IRC - Building

2019 GROUP B PUBLIC COMMENT AGENDA

2019 Public Comment Agenda

Figure 1 Hillside light-frame structure. Figure 2. Hillside structure cross-slope and out-of-hill loading.

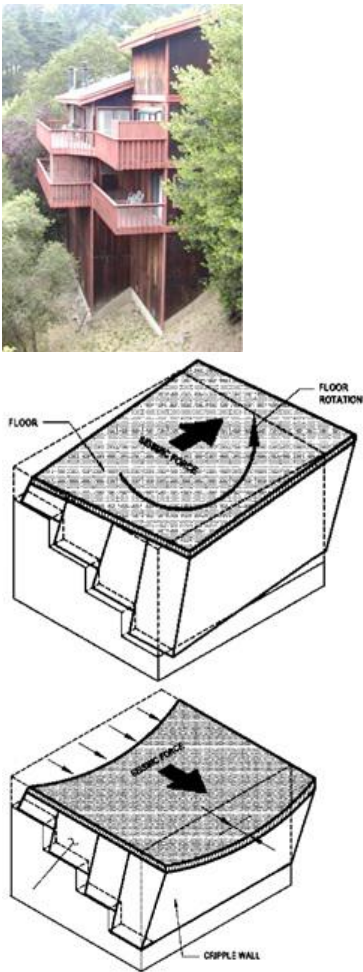
Reason: As part of work contributing to FEMA P-1100 (Vulnerability-Based Seismic Assessment and Retrofit of One- and Two-Family Dwellings Volume 1 - Prestandard), it was identified that for light-frame dwellings on steep hillsides (Figure 1), adequate seismic performance does not occur when seismic design is based on typical seismic force distribution assumptions (tributary area, flexible diaphragm). Whether loading is in the cross-slope or out-of-hill direction (Figure 2), seismic forces follow the stiffest load path to the uphill foundation, rather than distributing uniformly to all the bracing walls in the way assumed in development of IRC seismic bracing provisions. For this reason, design using the IRC bracing provisions will not provide adequate seismic performance. This change proposal triggers an engineered lateral force design for hillside dwellings by adding the hillside dwelling configuration to the already existing list of configurations deemed to be irregular for seismic design purposes.

Figure 5. Grade slope triggering the hillside dwelling irregularity exceeds 1 vertical in 5 horizontal across the full width of any side of the dwelling.

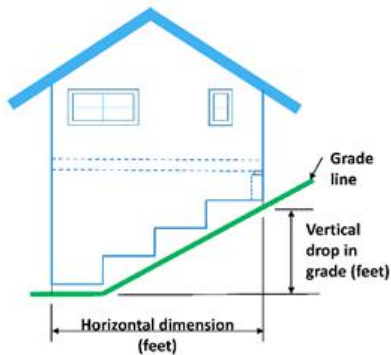
The Item 1 grade slope trigger is used to limit applicability of this irregularity to dwellings that are on sites with a significant slope (Figure 5). Averaging the grade slope along the side of the dwelling is intended to focus on the overall drop in grade elevation across the dwelling and not trigger the irregularity based only on limited areas of higher grade slope. This is consistent with the numerical studies that form the basis of this proposal. For most dwellings this criterion will be evaluated by looking at each of the four primary elevations. For large and more complex dwellings, additional “sides” will need to be evaluated.

Figure 6. Downhill cripple wall height triggering the hillside dwelling irregularity.

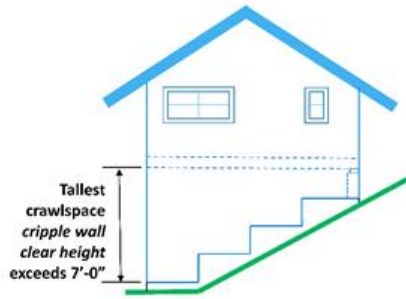
Item 2 adds a second trigger of downhill cripple wall height greater than 7'-0" (Figure 6) or downhill post clear height in post and pier dwelling (Figure 7) based on the FEMA P-1100 numerical studies. Both Items 1 and 2 need to be triggered in order to qualify for dwelling to be qualified as irregular. These triggers were observed to be the points at which damage and displacements at the uphill foundation were thought to significantly increase the likelihood of collapse.

Figure 8. Concrete or masonry wall configuration that does not trigger the hillside dwelling irregularity.

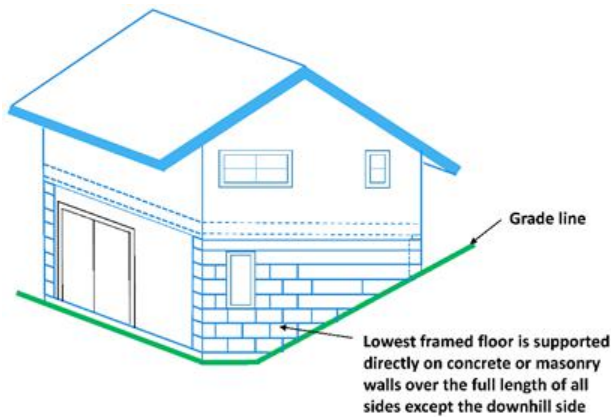
The exception scopes out of irregularity Item 8 dwellings that have full-height concrete or masonry walls (Figure 8) because this configuration was not part of the numerical studies that form the basis of this proposal. For a dwelling with a simple rectangular floor plan, full height concrete or masonry walls would need to occur on three sides to qualify for the exception. For a more complex dwelling plan configuration, additional concrete or masonry walls would be required to qualify for the exception. Dwellings with doors and windows in the concrete or masonry walls still qualify for the exception. In all dwellings the concrete or masonry walls will need to conform to applicable IRC provisions.

FIGURE 1 - IMAGINARY LINES BETWEEN TOWNHOUSES

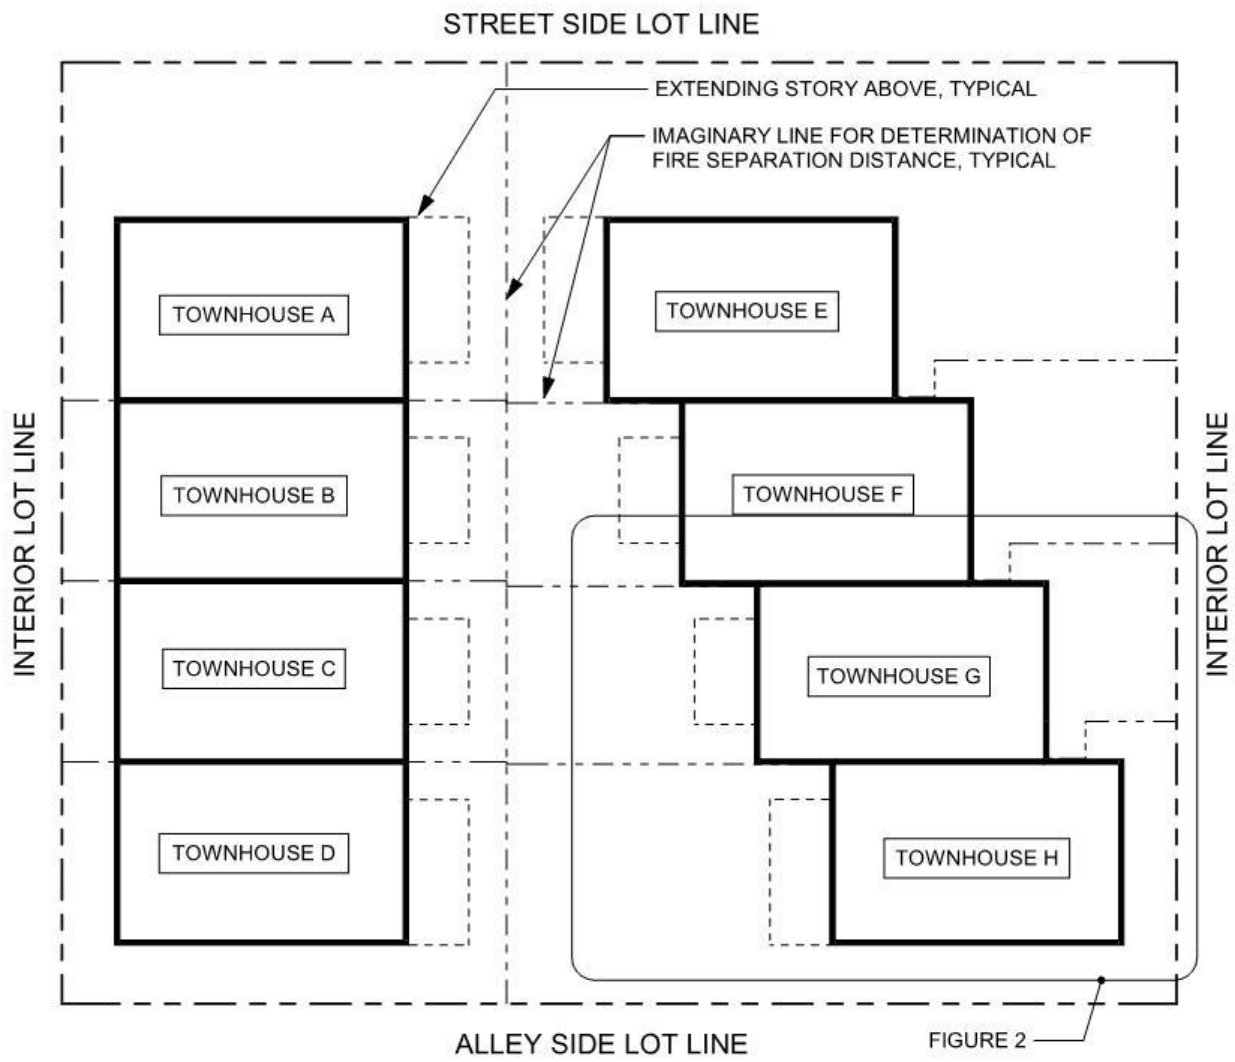
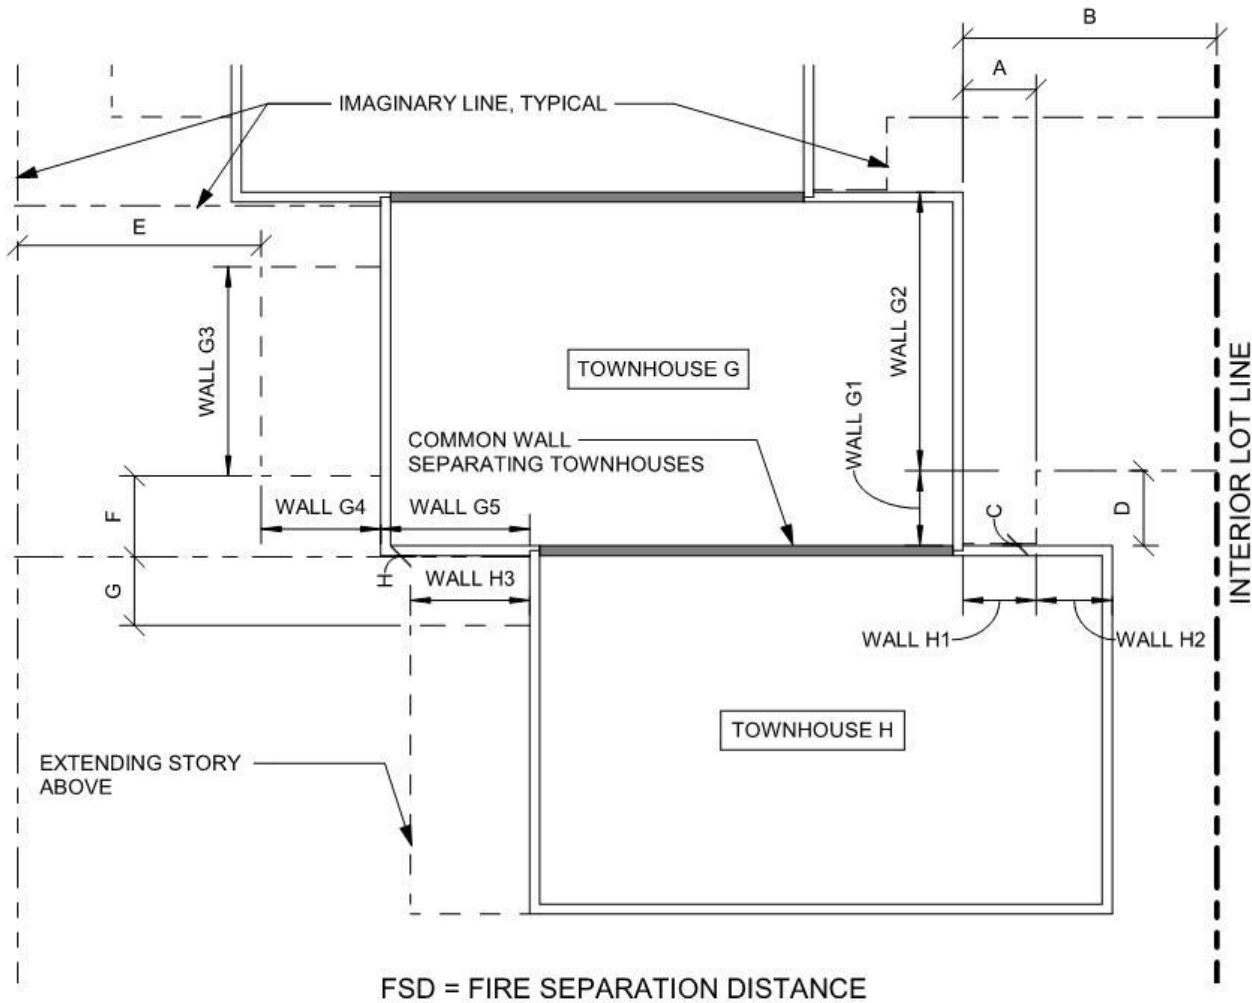
Reason: Prior to the 2015 IRC, Section R302.2 required each townhouse to be considered a separate building and be separated by fire-resistance-rated walls meeting requirements for exterior walls, with an exception to provide a fire-resistance-rated common wall. The 2015 IRC revised this section to only deal with common walls and a reference to exterior walls was removed. Since R302.1 only requires fire-resistance-rated exterior walls for *dwelling*s and accessory buildings, all townhouse exterior wall requirements were essentially removed from the code since a townhouse does not meet the definition of a *dwelling*. Prior to 2015 IBC, an imaginary line would be established between each townhouse since they were considered separate buildings and fire separation distance would be measured to the imaginary line, and it is believed that most jurisdictions still enforce this way.

This proposal brings back the 2012 townhouse exterior wall requirements that are assumed to have been inadvertently removed from the code. It does this by adding townhouses to the scoping of R302.1 for exterior walls and by revising the definition of fire separation distance to include imaginary lines between townhouses (rather than calling townhouses separate buildings, which they are not). Townhouse exterior walls that are adjacent to lot lines would meet exterior wall requirements based on fire separation distance to the lot lines. Townhouse exterior walls that are adjacent to other townhouses, would meet exterior wall requirements based on fire separation distance to the imaginary line between two townhouses. See Figures 1 and 2 below for application examples for this proposal. This proposal is necessary to fill the current hole in the code regarding exterior wall requirements for townhouses.

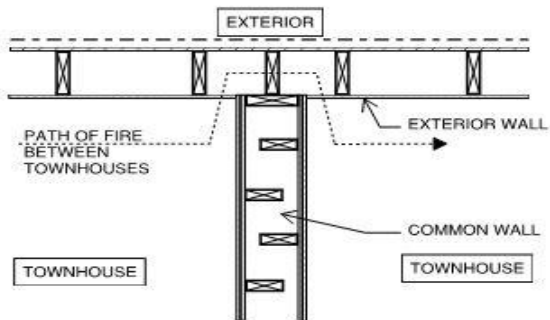
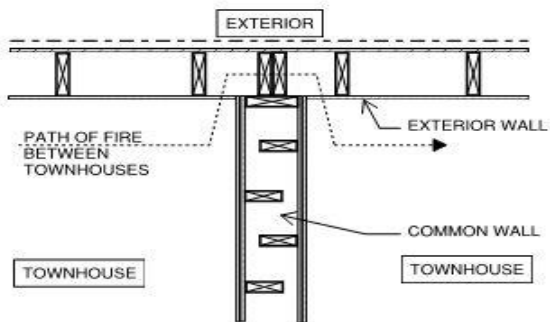
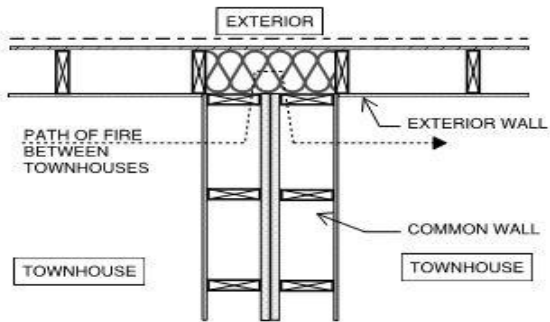
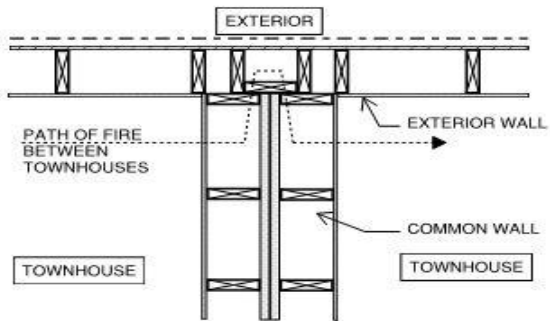
Commenter's Reason: We understand what the proponent was trying to achieve and support the overall proposal, but believe the language in the exception caused an unintended interpretation issue. Additionally we struggling to understand the constructability of the example the proponent provided.

This public comment addresses the interpretation issue of what "filled" actually means in the exception. WABO members indicated it meant the cavity should be completely blocked starting with a minimum of two, two inch wood studs. This cavity could be required to be blocked with 4, 5, or 6, wood studs. We do not believe this was the intent of the proposal and believe the language provided in this public comment provides a greater clarity for these areas.

Comparison of IRC Requirements to IBC Requirements for Figure 1 and Figure 2

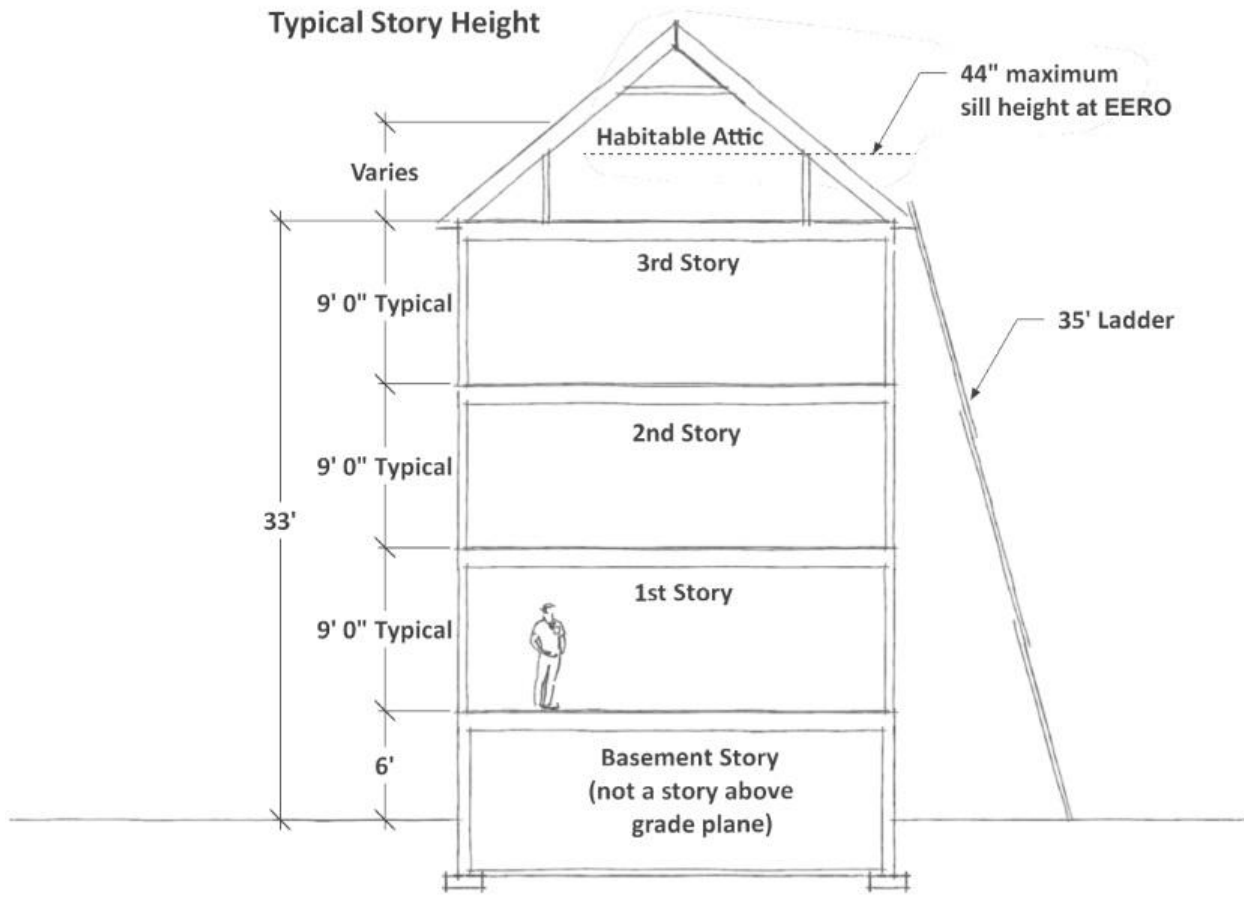
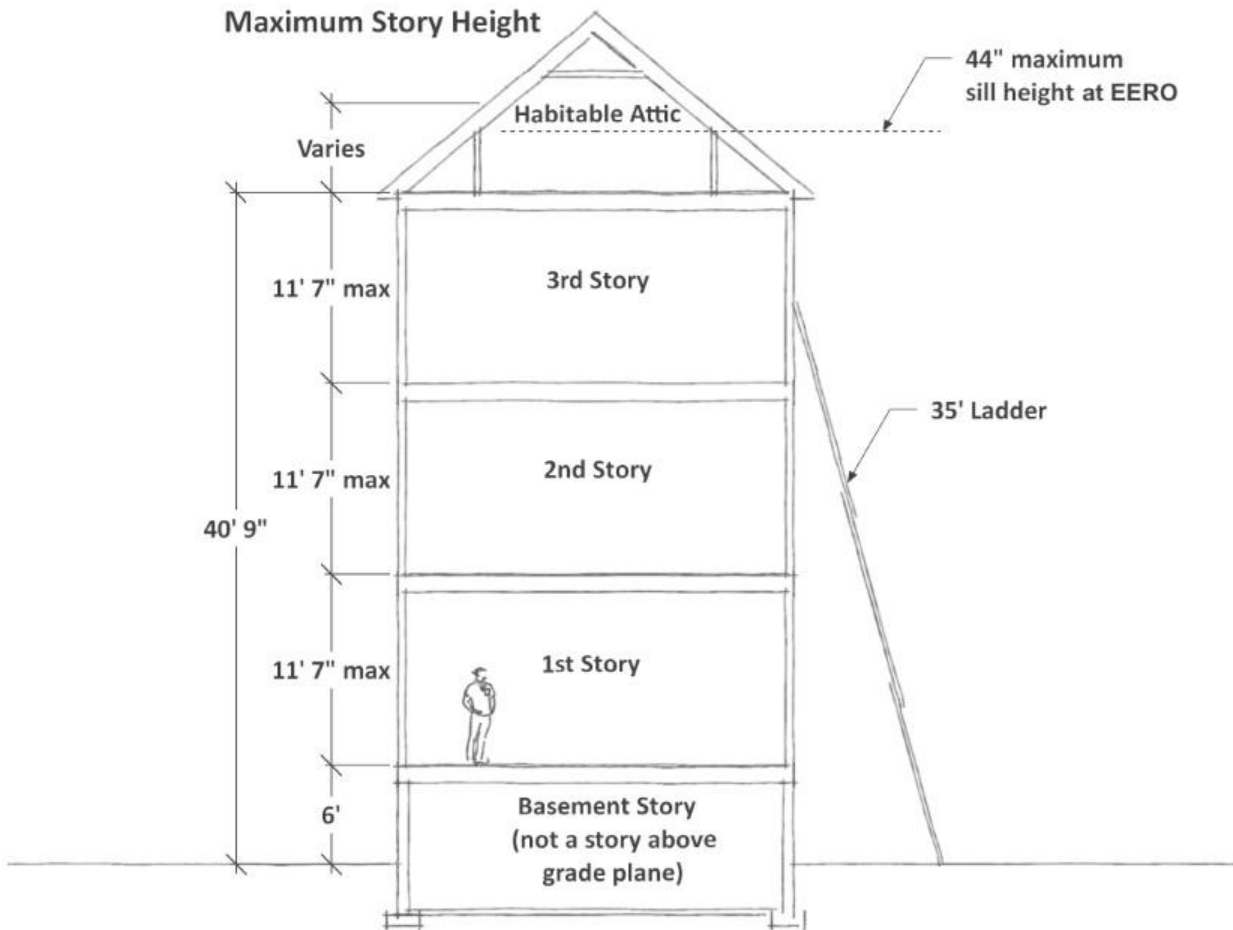
For a three-story, one-family dwelling with habitable space in the attic, the maximum story height is limited to 11'-7" in both the IRC and the IBC. Using both a typical story height (8'-0" ceiling height with a 1'-0" structural space) and the maximum story height, the following figures illustrate some possible building heights that can be achieved. Along with this comparison, Table 1 highlights some life-safety features that would result when these structures are constructed under either the IRC or the IBC. It should also be noted that the code currently does not bring into consideration habitable attics that include dormers or various roof styles (such as a mansard roof) that could easily blur the lines of the current definitions and create spaces that appear to miss the intentions of the original code change proposal.

As is shown in Table 1, the result of applying either the IRC or the IBC would result in different safety levels for the same structure.
